MEMO

SP-2022-07, Pamela Hausser, 73 Hardwick Pond Road, Dog Kennel

NHESP Estimated Habitats of Rare Wildlife

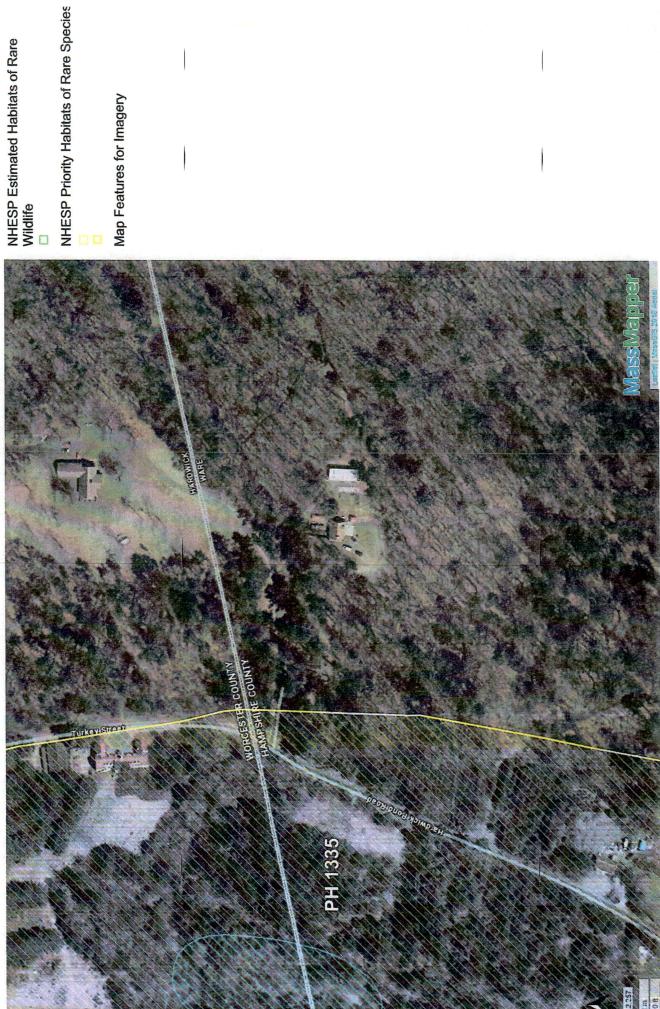
After reviewing the SP-2022-07 Application and business plan for the above applicant, the first 130-140 feet of the existing driveway is located within NHESP Priority Habitat Polygon #1335 (see attached map). Should any work/improvements be proposed within this polygon, the applicant will need to coordinate with NHESP.
